Our Case Number: ABP-316212-23

Re: Proposed development of 26 no. wind turbines and associated works.
at the Ballivor Bog Group, Co. Meath and Co. Westmeath.

Re: Ballivor Wind Farm ABP-316212-23 – MCC's Comments on Significant Additional Information

Fig. 1: Cumulative Context Update (Source: Response to Observations Received)

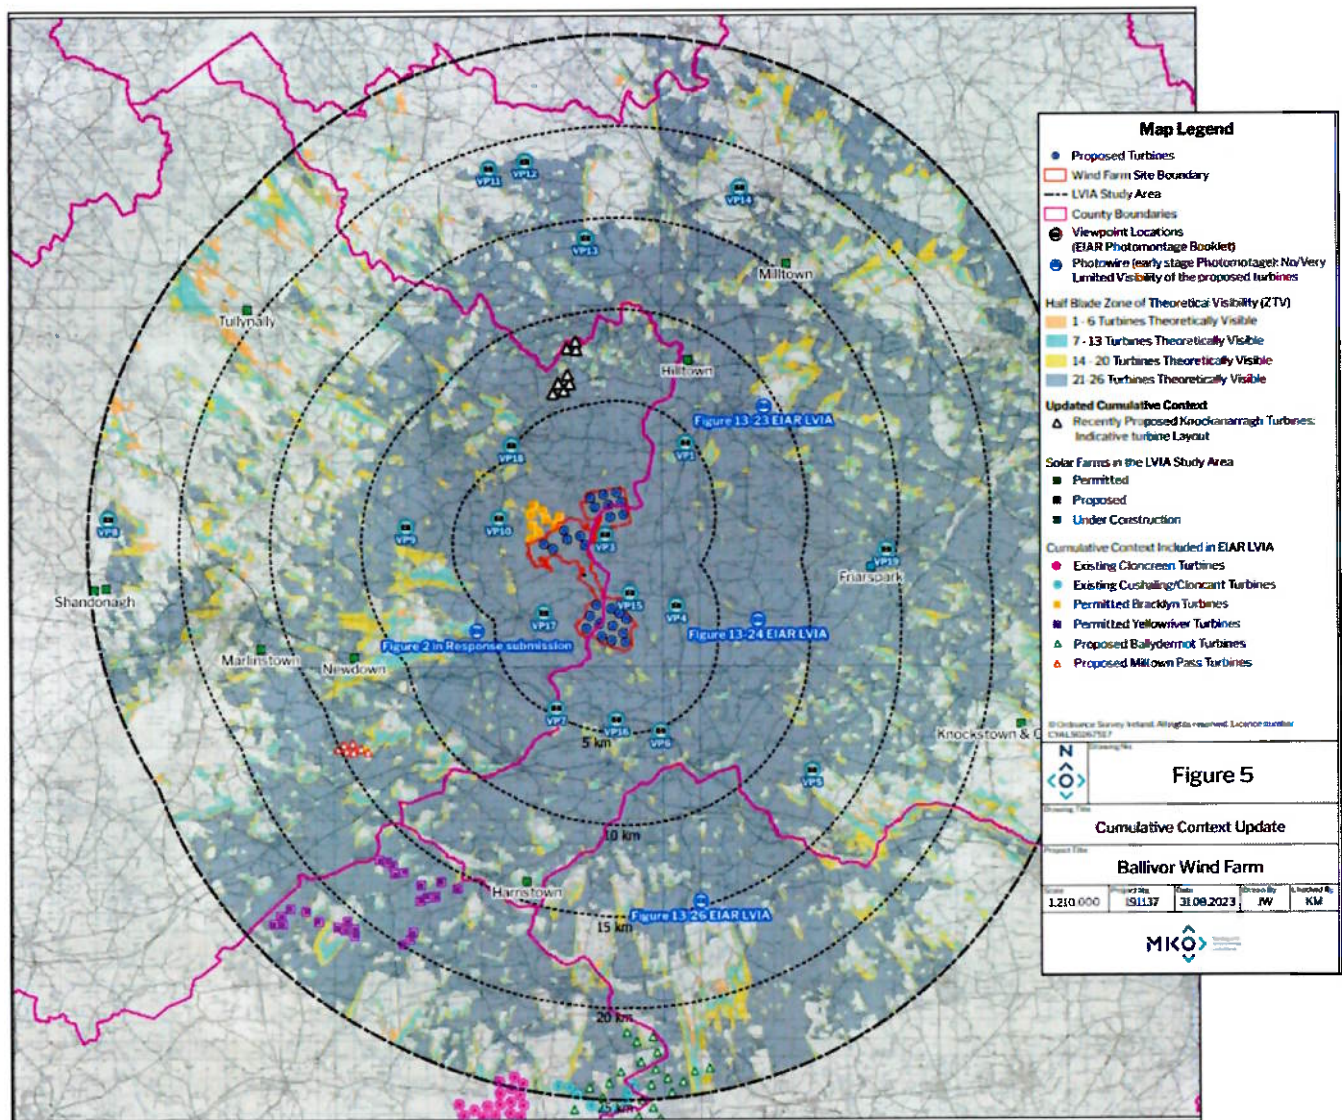
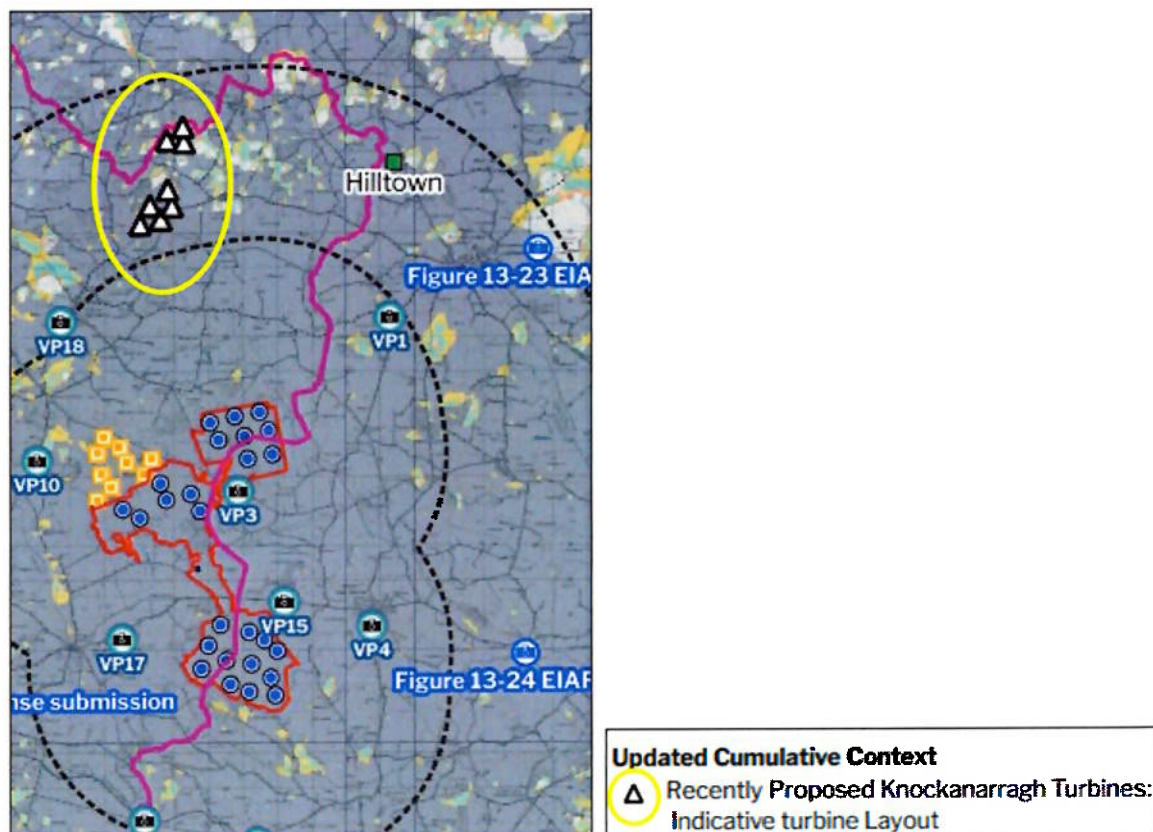
The location of all nearby existing, permitted and proposed wind turbines was updated and presented on the following Zone of Theoretical Visibility map, submitted with the applicant's 'Response to Observations Received'. The applicant has included a colour coding (not available in the EIAR submitted for the SID application) and it illustrates the likely visibility of turbines within a 25km radius of the proposed development (see Figure 1).
